ENGINEERING CHANGE NOTICE

DART AEROSPACE LTD				Amendment Design Review (ADR) Yes/No: Yes		ECN #: 865	
Date: 06.11.07				ADR Date: 06.09.26			
Job No: 00075				Created By: <i>UP</i>		Checked By: <i>RLH</i>	
Product No: D412-630				Approved By:		Approved By:	
Product Name: Heli-Access-Step				(Proj. Manager)		(Management if reqd)	
Documents Affected:							
Release:							
-D2804 Rev.C -D412-630 Rev.K							
-D3560 Rev.A -ICA-D412-630 Rev.2							
-D3562 Rev.A -FMS-D412-630 Rev.E							
-D3563 Rev.A

Description / Action:

D412-630-033/-034 Kit

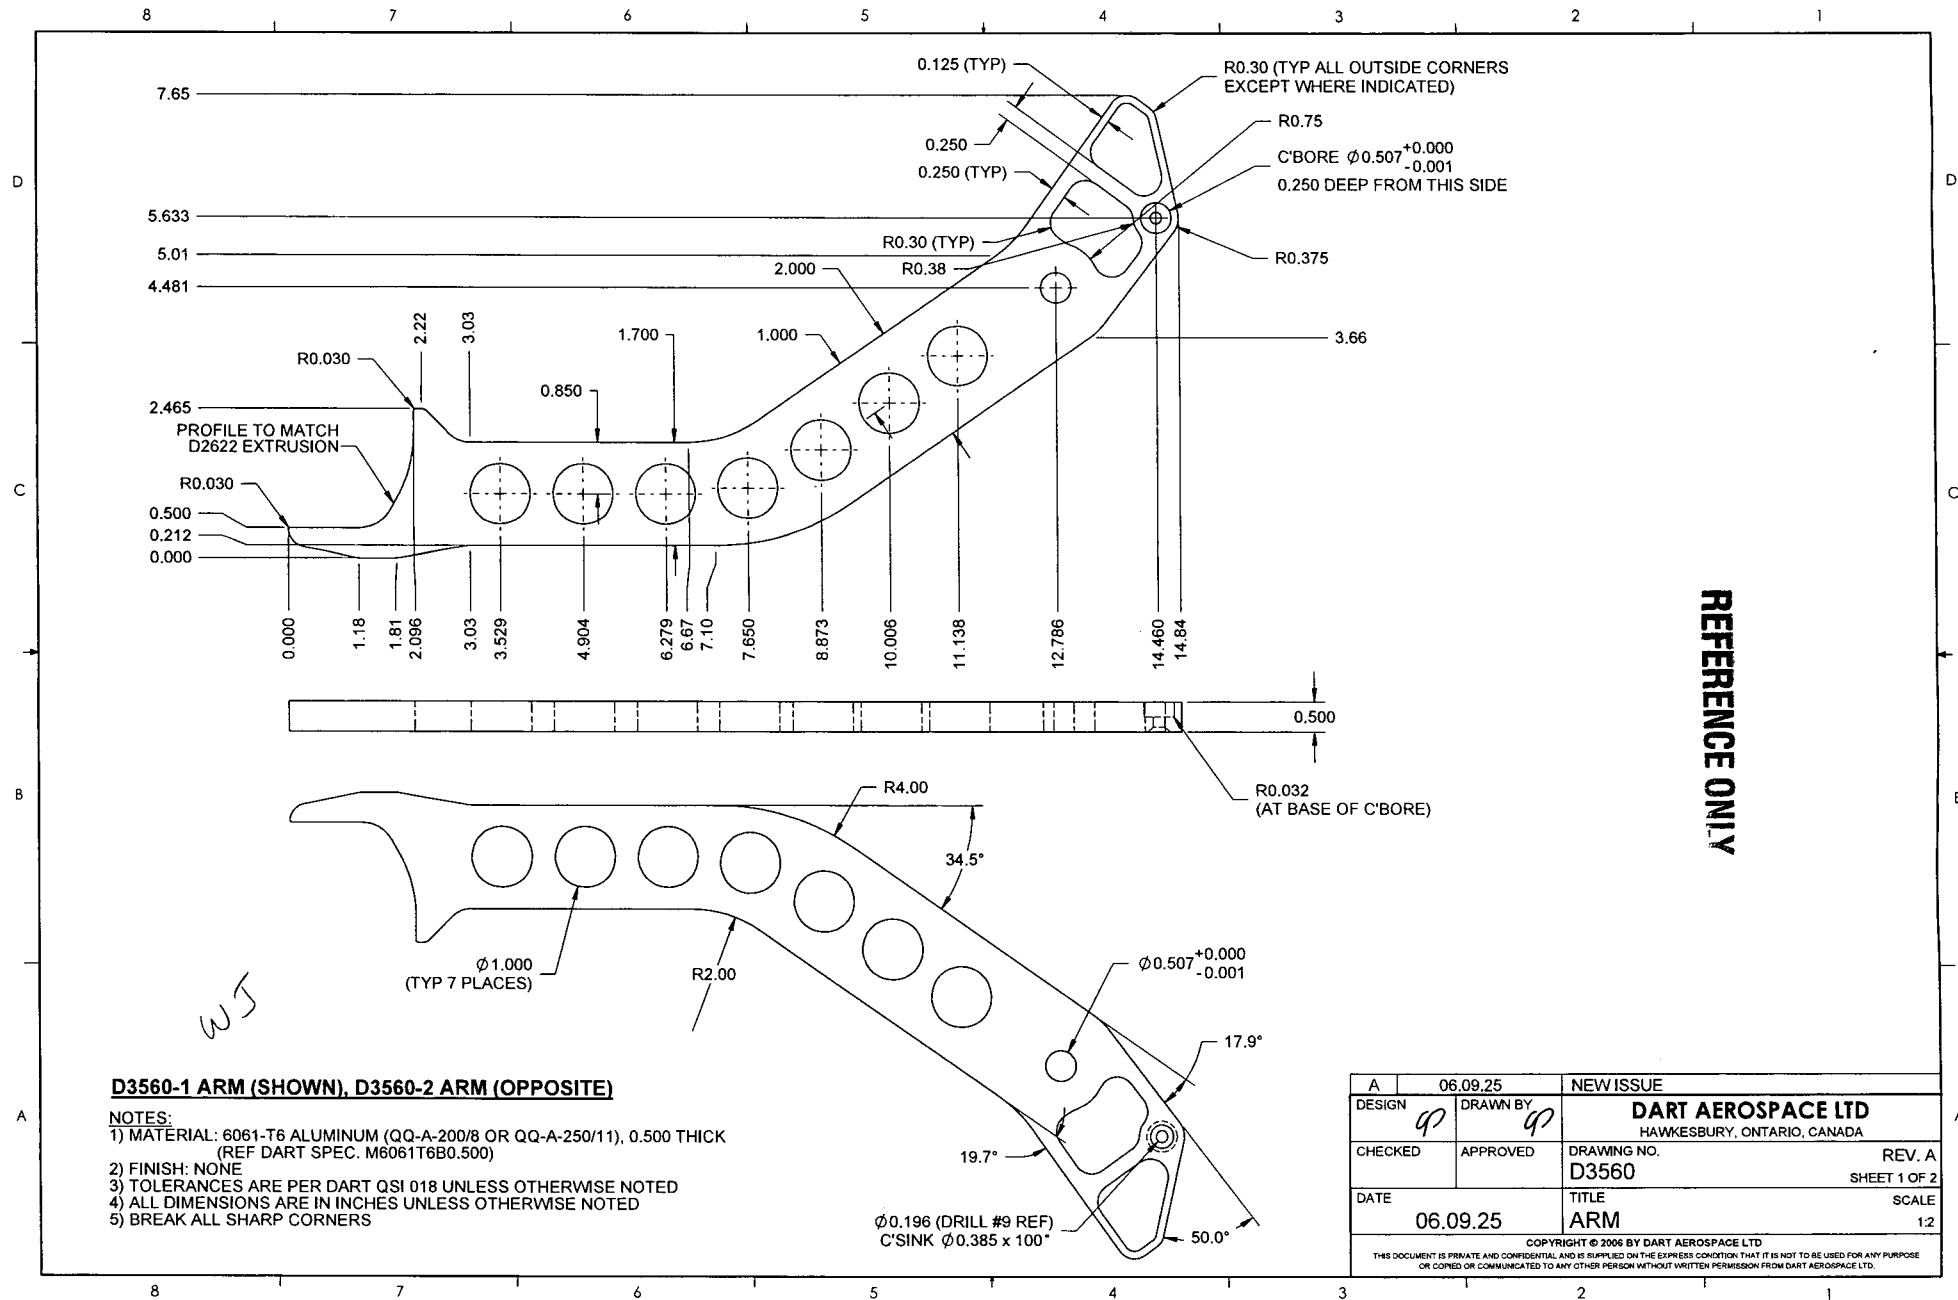
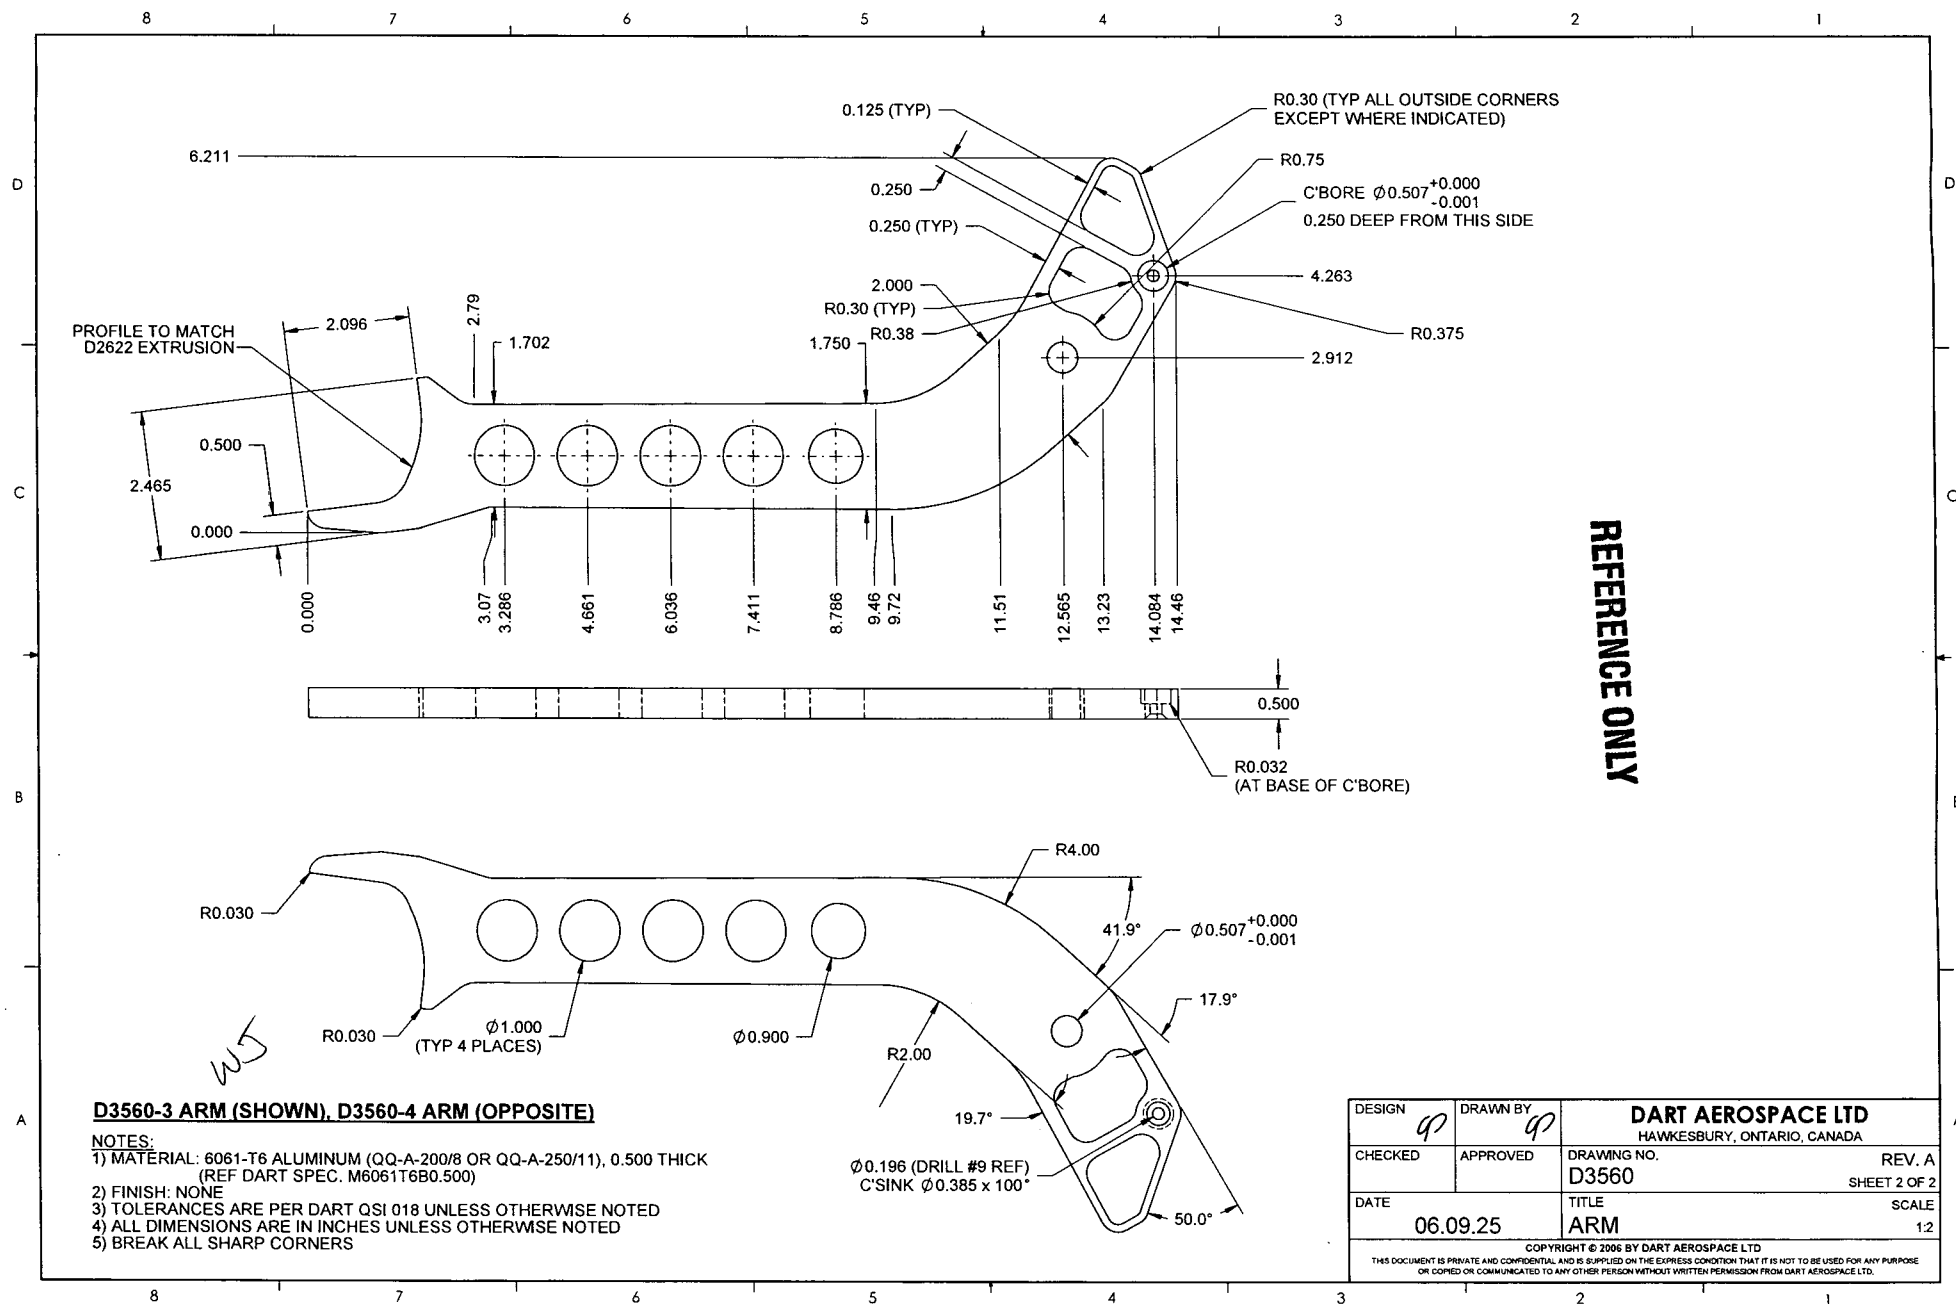
- new kits at CHG#001 ✓
- similar to -023/-024 kit, but has different step weldment (D3562-041/-042)

D3562-041 LH STEP ASSEMBLY (SHOWN)
D3562-042 RH STEP ASSEMBLY (OPPOSITE)

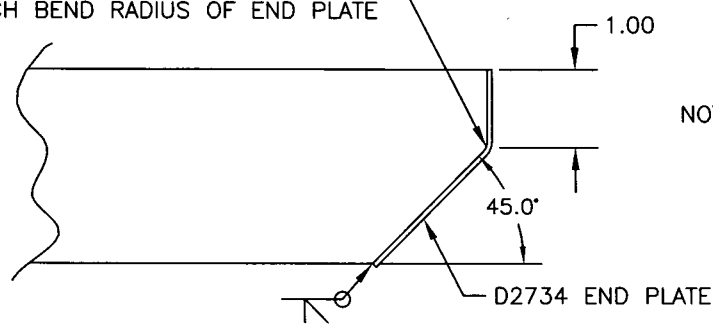
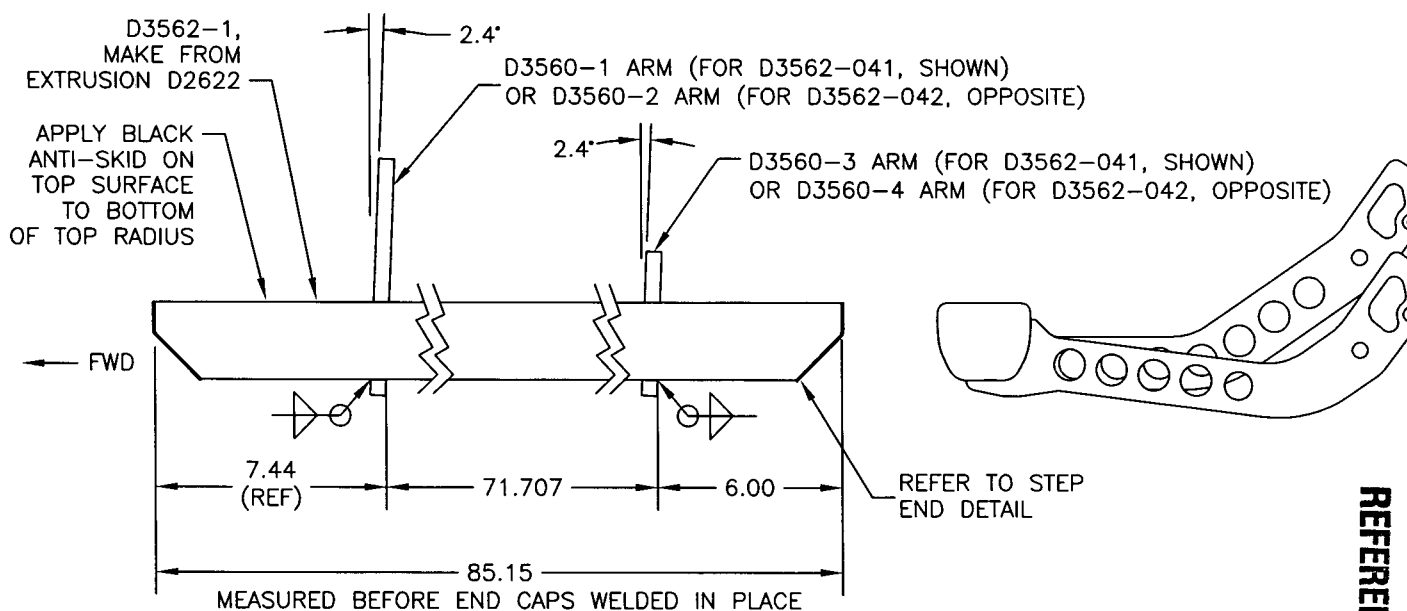
D3562-041/-042 Step Weldment

- new part for -033/-034 step kits.
- uses new D3560 arms
- needs special weld jig because arms are mounted at an angle.
- need to make prototype using jig for engineering test fit before making large quantities.

ROUND CORNER OF EXTRUSION TO
MATCH BEND RADIUS OF END PLATE

D3563-X EYEBOLT

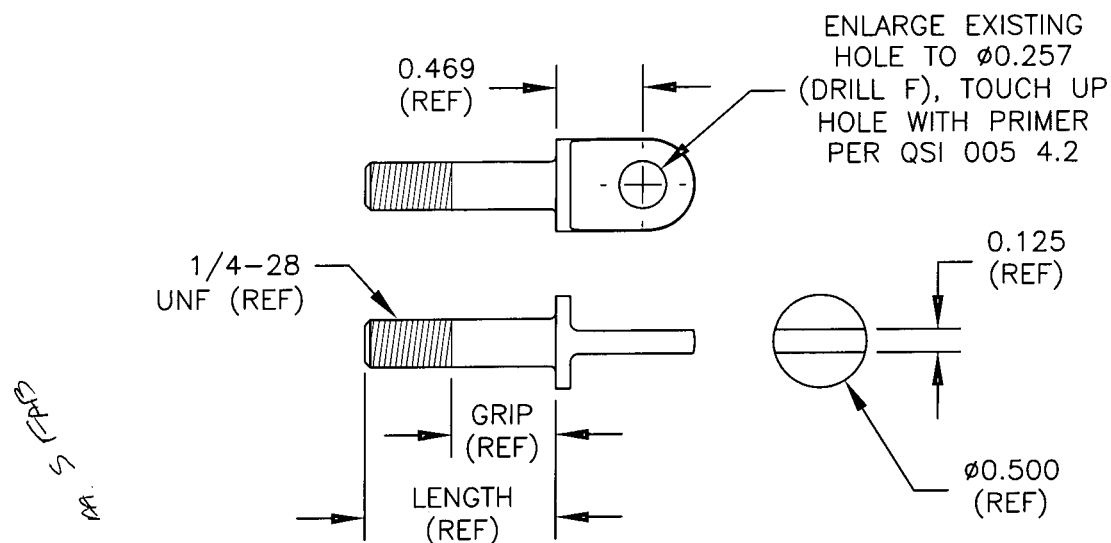
D3563-10 Eyebolt

- new part for -013/-014 step kits.
- basically a drilled/primed AN43B-10A eyebolt

- 1) MAKE FROM: AN43B-XA EYEBOLT, CAD PLATED STEEL WITH UNDRILLED SHANK
- 2) SPECIFICATION: D3563-X EYEBOLT

FIGURE 8 – STA 84.29 for D412-630-013/-014 Heli-Access-Step™ Installation
(View rotated 90° CW)

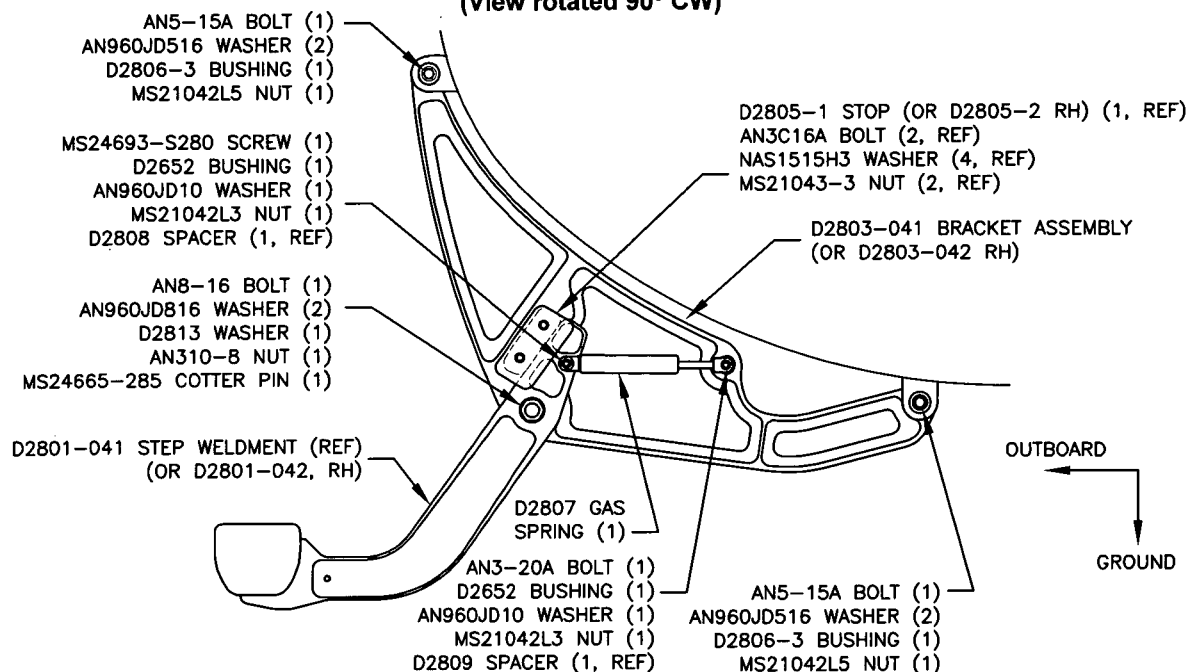
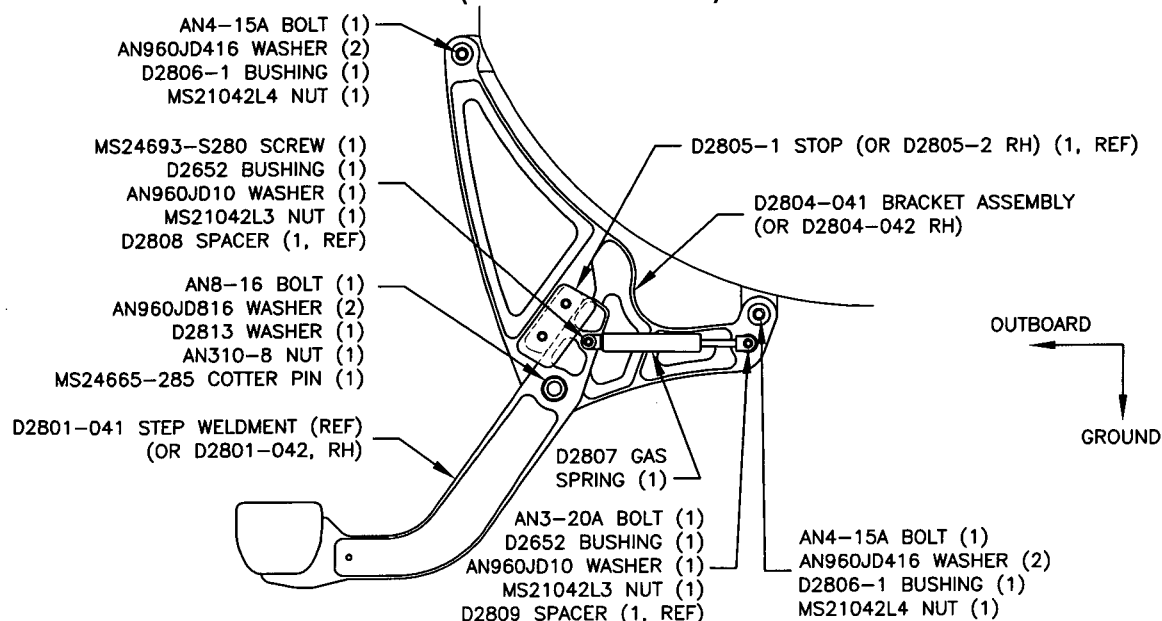
- a) The step was contacting the aircraft when folded upwards.
- b) Interference between the D2804-043/-044 brackets and a hose coupling on their emergency float system.
- c) The D2810-1 strut was contacting some stainless steel conduit for the emergency float system on some aircraft. On the remaining aircraft the strut was very close.
- d) Wording in the installation instructions (IIN-D412-630 Rev.J) was not clear as to which hardpoint the D2801-1 strut should connect to.

- a) The forward brackets have been changed from D2803-043/-044 to D2803-041/-042 and the aft brackets from D2804-043/-044 to D2804-041/-042. These brackets are designed so the step is further away from the aircraft in the folded position and there is no longer any possibility of contacting the aircraft when folded. The D2803-041/-042 and D2804-041/-042 brackets are the same part number used successfully on the D412-630-011/-012 and D412-630-023/-024 steps. Additionally these brackets had originally been part of the D412-630-013/-014 steps manufactured prior to the year 2001.

- b) The D2804-041/-042 brackets that are now included in all D412-630-013/-014 kits have had a minor redesign. An additional 3/8" (9mm) of clearance has been provided in the area of the emergency float system coupling, which will eliminate the possibility of contact. This design change is minor: the overall design change has been kept to a minimum, all attaching holes are exactly the same, the altered area of the bracket is as strong or stronger than the previous design, and the bracket is in an area where it will not cause any interference with inflated emergency floats.

FIGURE 10 – Strut Detail for D412-630-013/-014 *Heli-Access-Step*™ Installation
(NOT TO SCALE)

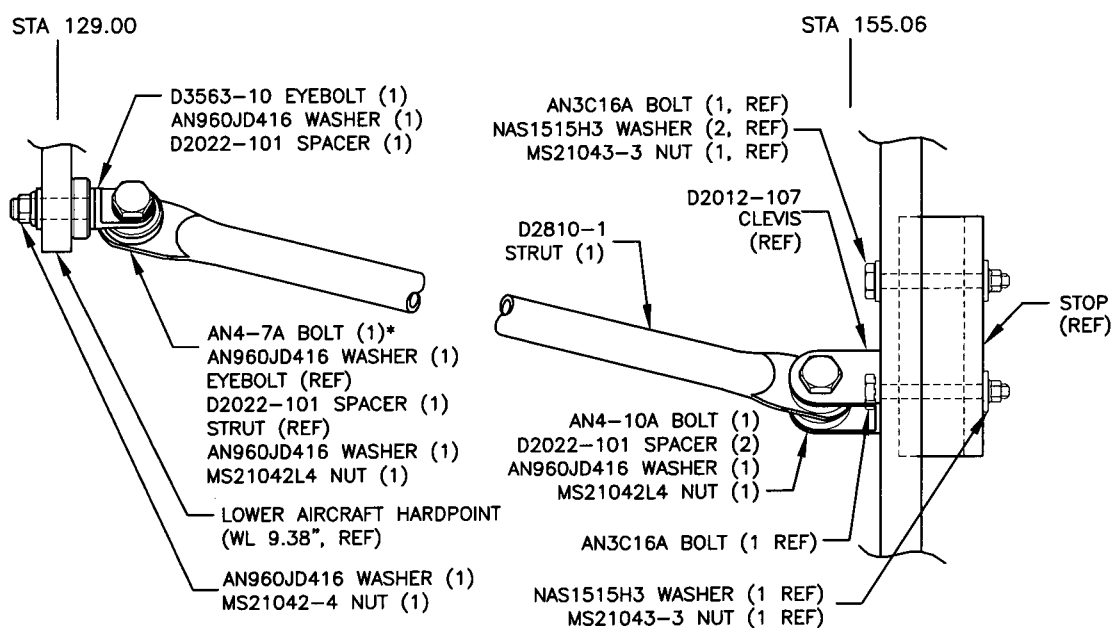
- c) The attachment of the D2810-1 strut to the aircraft hardpoint has been changed to an D3563-10 eyebolt (AN43B-10A drilled to accept 1/4" bolt). This will allow the strut to be moved downwards, allowing the strut to clear the emergency float system's conduit.

* IF ADJUSTMENT OF THE STRUT IS REQUIRED TO AVOID OTHER HARDWARE ON THE AIRCRAFT, IT IS ACCEPTABLE TO USE LONGER AN4 BOLTS AND ADDITIONAL WASHERS AS REQUIRED TO ADJUST THE ATTACHMENT OF THE D2810-1 STRUT TO THE EYEBOLT.
